Land to the rear of 74 Hookhams Lane,  
Renhold

Technical Note- Response to Highway  
Authority Comments

December 2019

REPORT TITLE:	<b>TECHNICAL NOTE- RESPONSE TO HIGHWAYS COMMENTS</b>		
PREPARED BY:	[REDACTED]	DATE:	<b>DECEMBER 2019</b>
CHECKED BY:	[REDACTED]	DATE:	<b>DECEMBER 2019</b>

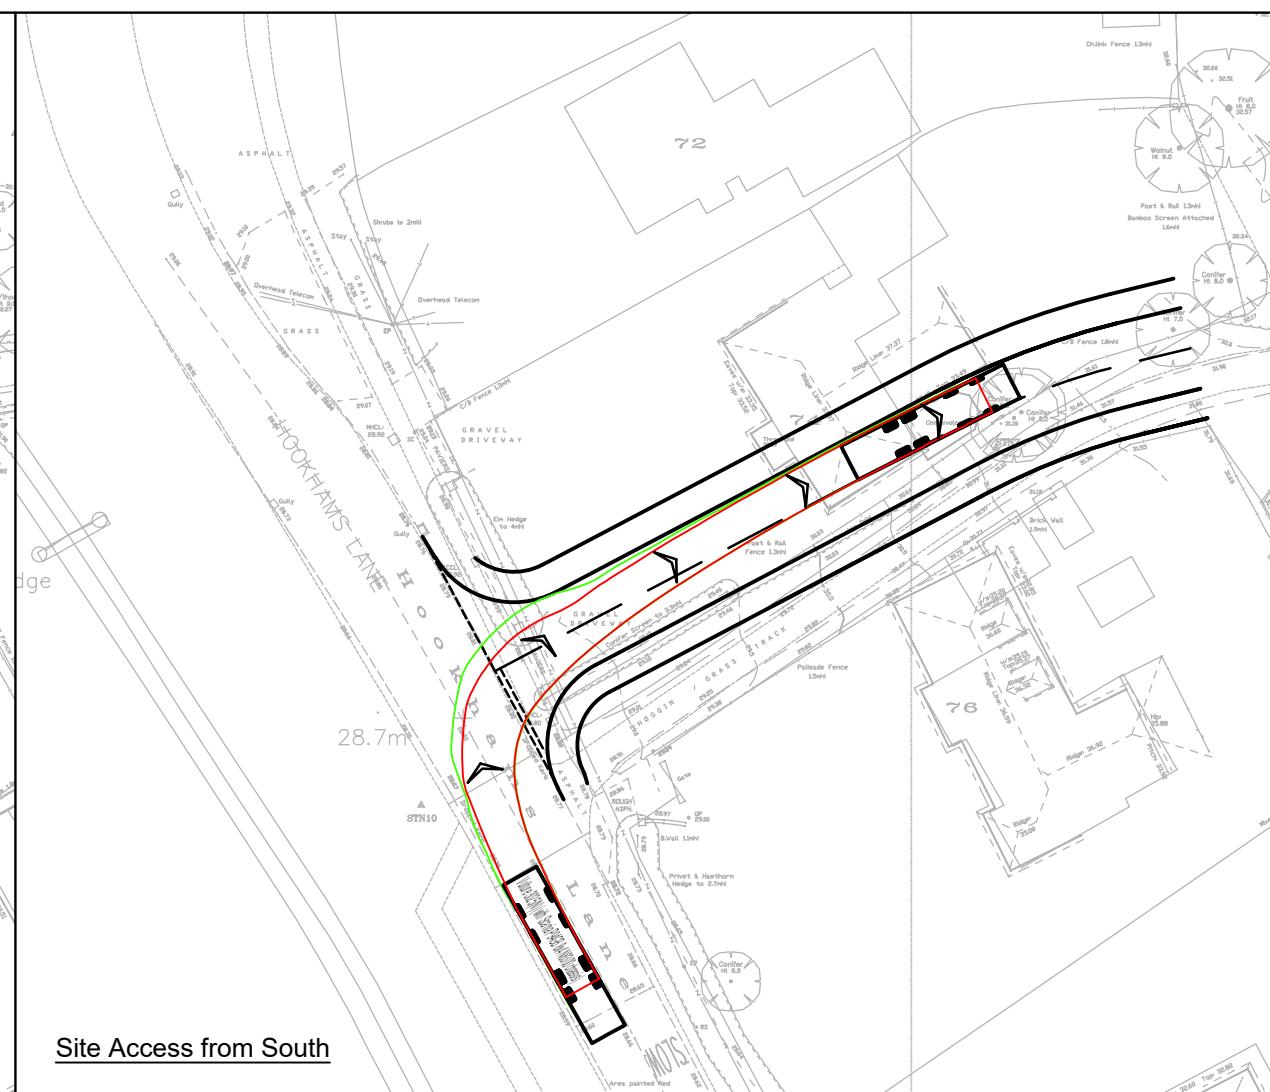
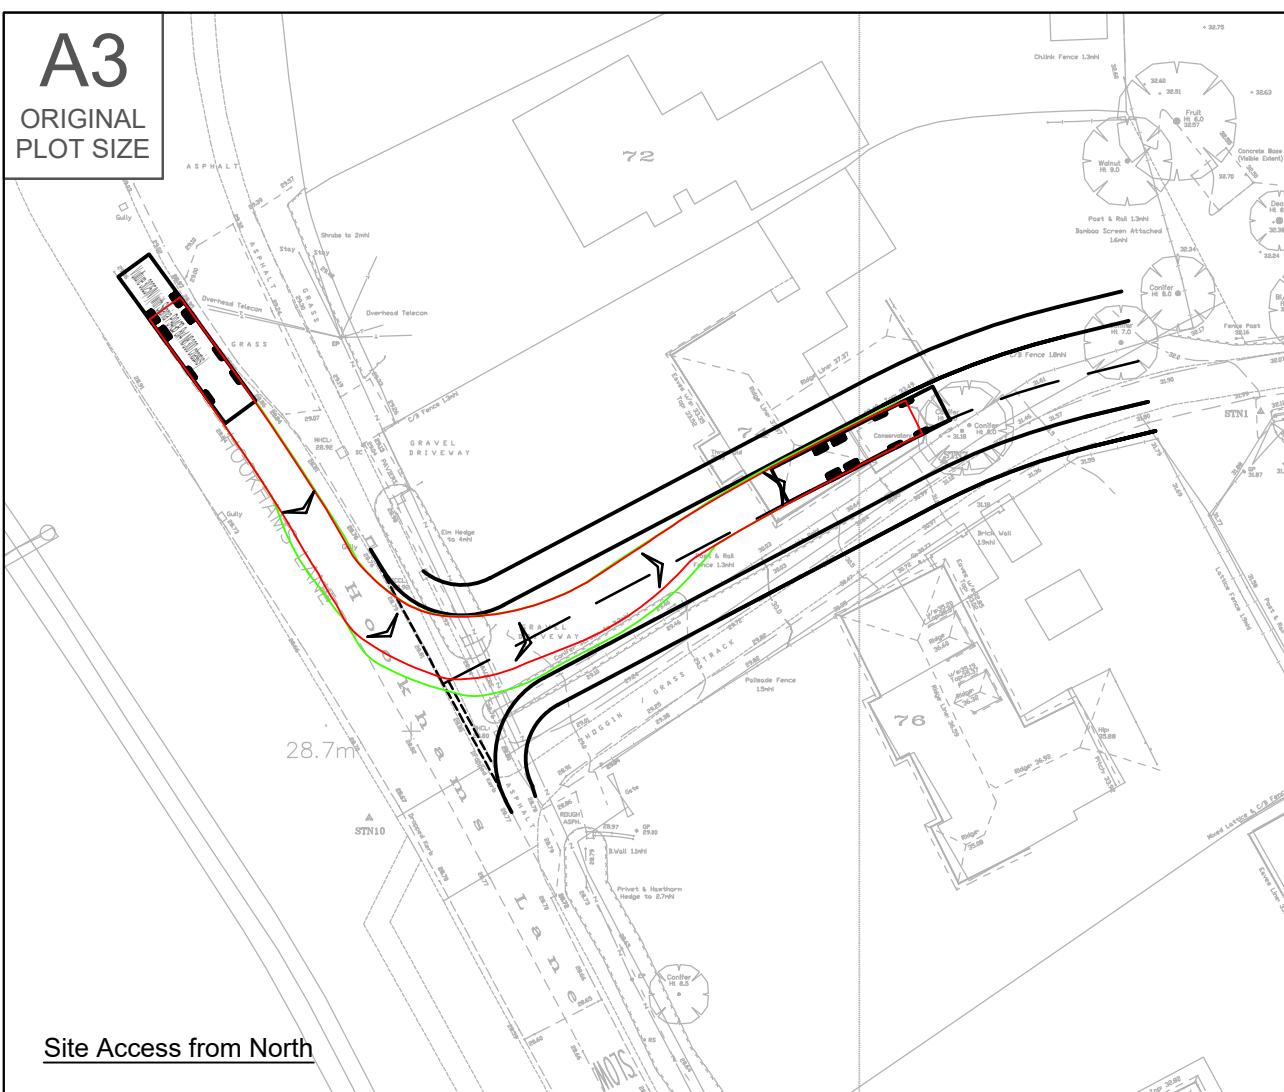
***The proposed access road is 6M wide with a reduced radii. A 6M access is only required for a bus route. The access road should be 5.5M wide with a 4-6M radius (not a 10M radius). It is correct to reduce the bellmouth of the access to assist pedestrians crossing the road.***

***The existing access of number 76, must not be within the bellmouth of the site access.***

***The site access is required to have 2 x 1.8m pedestrian splays each side of the access, before the highway boundary. The access to number 76 must keep a 1.8M pedestrian splay before the highway boundary which is not affected by the proposed site access.***

- 2.7 The site access road has now been reduced in width to 5.5m as requested. In addition, the radii at the junction have been reduced to 6m. The revised site access proposal is shown in CTP drawing CTP-19-374 SK02 Rev B, which is provided at **Appendix A**. Swept path analysis has also been undertaken to confirm that the BBC refuse vehicle can satisfactorily enter and exit the site.

- 2.8 The access to no. 76 Hookhams Lane is not within the bellmouth of the junction. The revised access drawing shows the location of the access to no. 76 to the south of the proposed site access junction.

- 2.9 It is unclear why the proposed site access is required to have pedestrian visibility splays when a 2m footway is provided on both sides of the access to connect with the existing footway on Hookhams Lane. A 1.8m pedestrian splay will therefore be contained within this footway.

- 2.10 The pedestrian splay at the access to no. 76 Hookhams Lane will remain as existing. Due to the location of the access at the northern extent of the property boundary, it is currently not possible to provide a 1.8m pedestrian splay at the access to no. 76 without using land within the application site.

- 2.11 As such, the pedestrian splay will remain as at present since no. 76 lies outside of the application site boundary.

## **APPENDIX B: Accident Data**

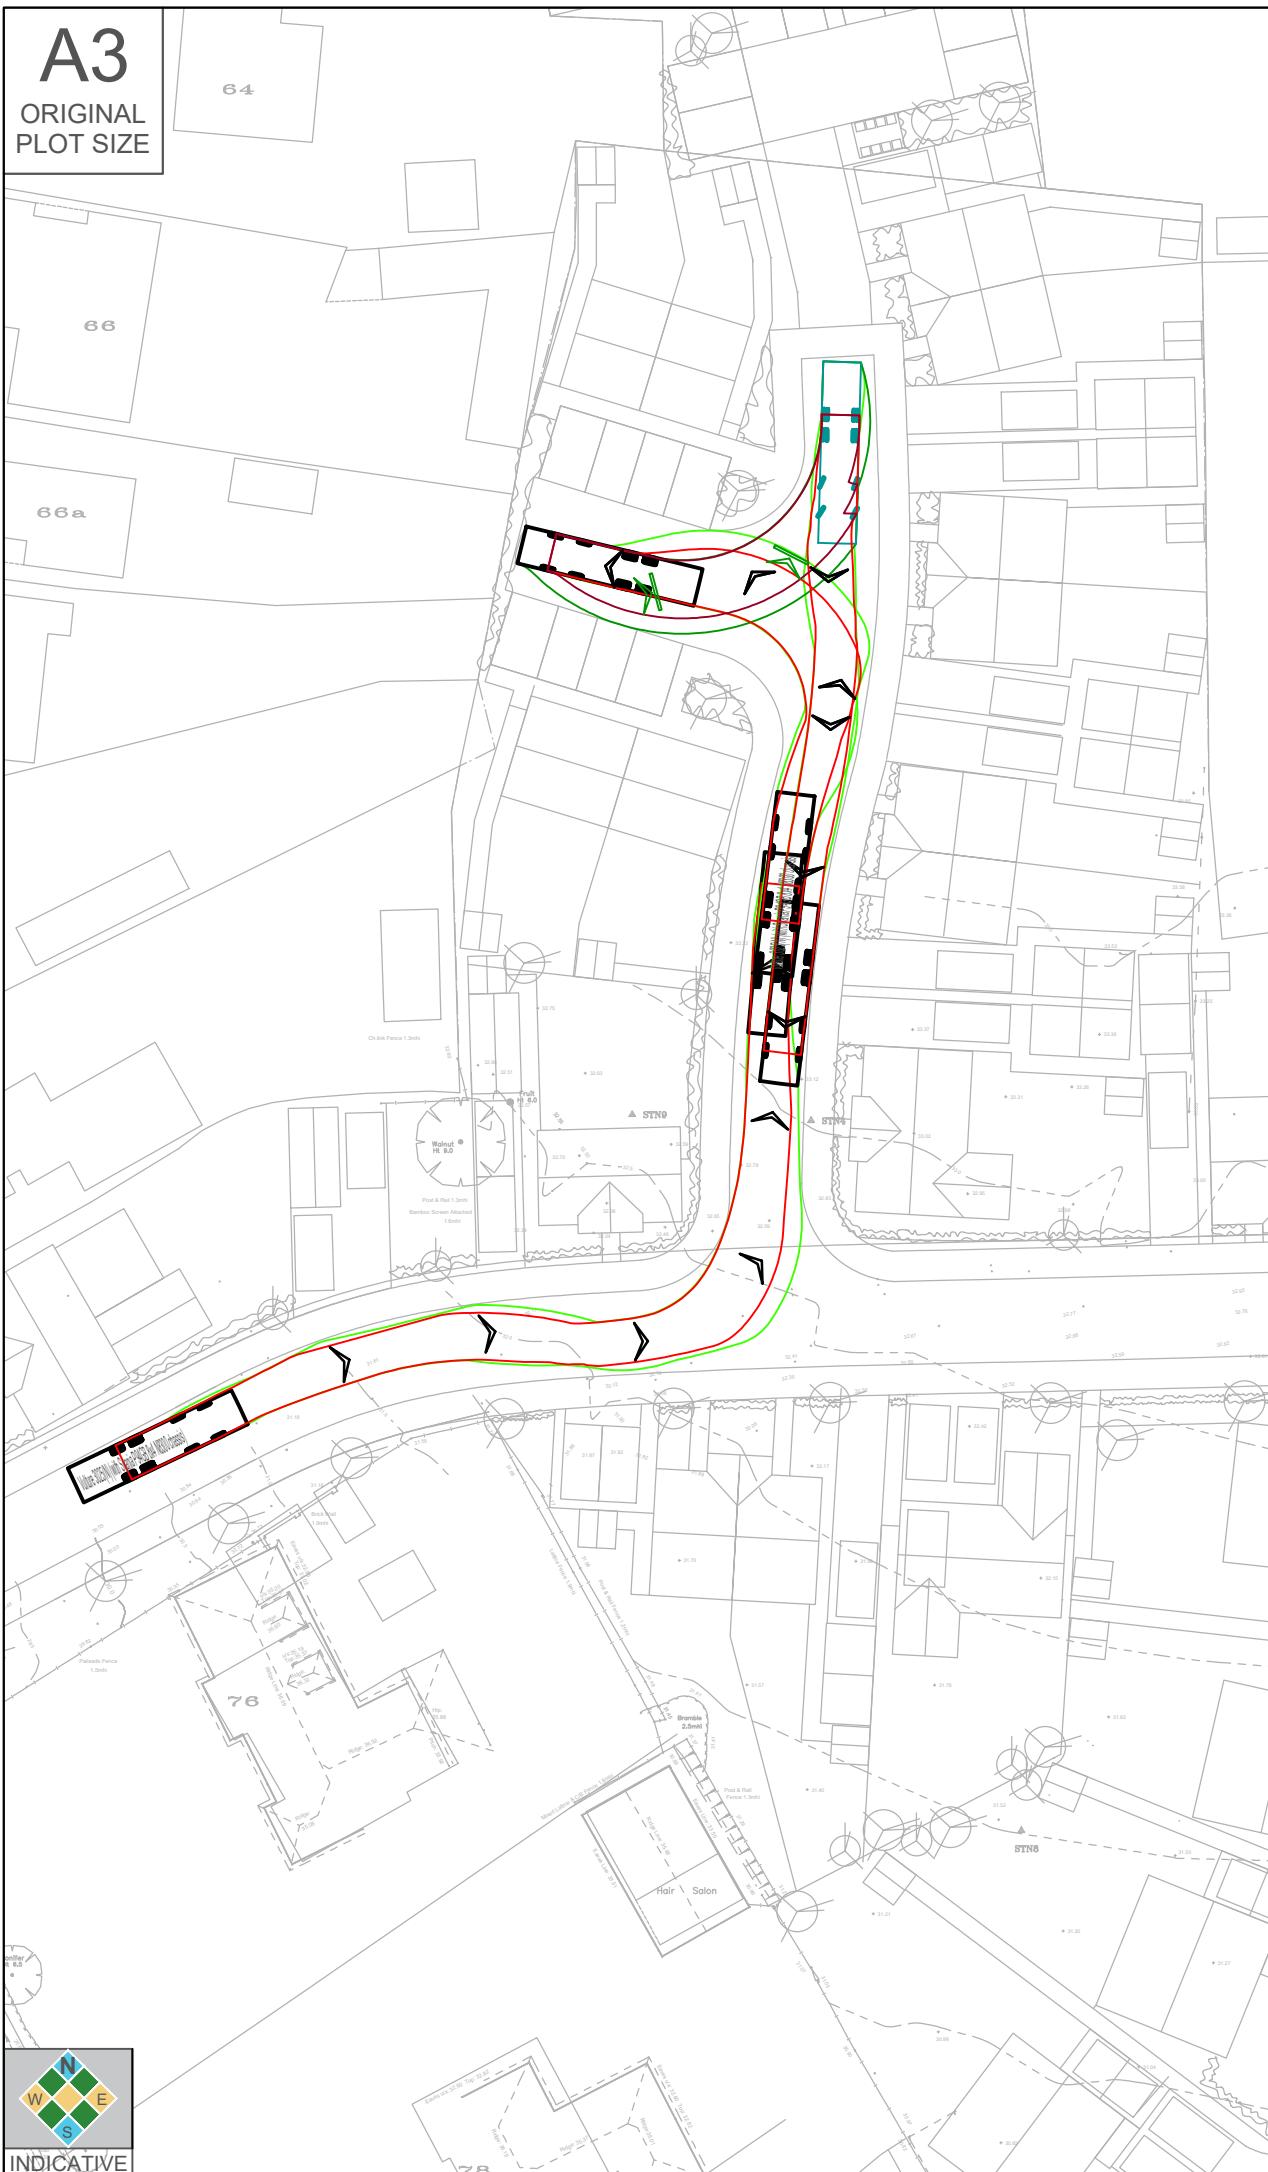
***Four accidents have been identified near to the Norse Road roundabout. The accidents need to be investigated and analysed.***

- 
- 2.12 Accident data has been obtained from BBC for the period 01/01/2014 – 09/10/19. No more recent data is available. This data is provided in full at **Appendix B**. This data shows three recorded accidents near to Norse Road roundabout. Of these, one was classified as serious with the remaining two classified as slight.

- 2.13 The serious accident was recorded on Norse Road 10m to the south of the roundabout with Hookhams Lane and was the result of a vehicle leaving the carriageway and colliding with a tree. No other vehicles were involved.

- 2.14 One slight accident occurred on Hookhams Lane to the north of the roundabout and was the result of a cyclist overtaking a queue of traffic behind a van that was letting a pedestrian cross the road, and a car travelling in the opposite direction collided with the cyclist.

- 2.15 The final slight accident occurred on the roundabout and was the result of a car travelling from Hookhams Lane to Church Lane failing to see a cyclist on the roundabout and pulling onto the roundabout into the path of the cyclist.

- 2.16 This accident record is not considered to be indicative of any road safety issues on the local highway network. Three accidents over a five year period is not significant, whilst all of the accidents occurred in different locations and were the result of varying factors, none of which are considered to be highway design issue or indicative of any issues with the road layout.
